## STAFF REPORT

**MEETING DATE:** July 26, 2021

**AGENDA ITEM TITLE:** Wood Minor Subdivision – Limited Impact Review

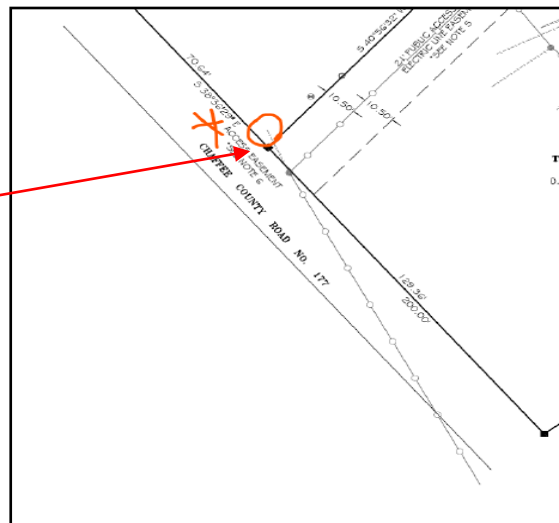
**Xcel Energy, Sterling Waugh:** I would request that all access easements are also utility easements and all existing utilities, including guy wires, be placed in an utility easement.

I have a screen shot of the guy wire that is Xcel's that should be in an easement and the access easement that should also be an utility easement.

1. Remove the City Administrator signature block.
2. Easements for the central water and wastewater systems must be shown on the plat.
3. The requirement of Xcel for utility easements must be shown on the plat.
4. A plat note be added stating that “Pursuant to Section 13-2-60 of the Salida Municipal Code: If the properties are developed with well and on-site wastewater treatment systems, either individual or central, and a new water or sewer main is extended within (four hundred) 400 feet of the property they will be allowed to continue such use until such time as the well or
